5-15 Rynan Avenue, Edmondson Park

BCA Assessment Report

REPORT 2015/2200 R1.2

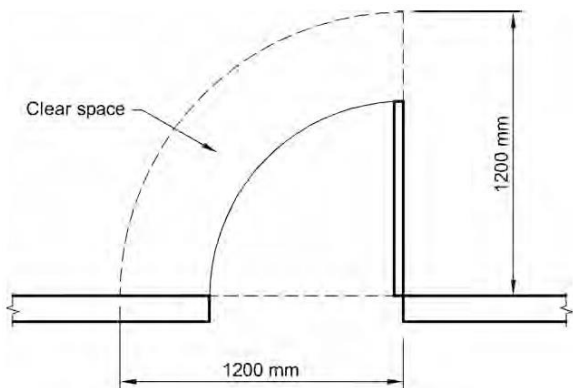
Clause	Description	Status	Comments
		Alternative Solution	The booster assembly located outside Block B & C adjacent the basement carpark driveway is located within 10m of the external building. The shield wall does not extend 2m either side of the booster assembly as required by AS2419.1. This non-compliance is proposed to be addressed as part of a fire engineered alternative solution.
E1.4	Hose reels	Compliance Readily Achievable	Fire hose reels are to be installed internally within 4m of an exit or internally adjacent to a fire hydrant so that the fire hose reel will not need to pass through fire and smoke doors in the basement carpark in both Blocks. Additional hose reels are permitted to be installed further than 4m from exit to achieve coverage. Fire hose reels are to be installed accordance with AS2441. Design details demonstrating compliance are to be provided with the Construction Certificate application.
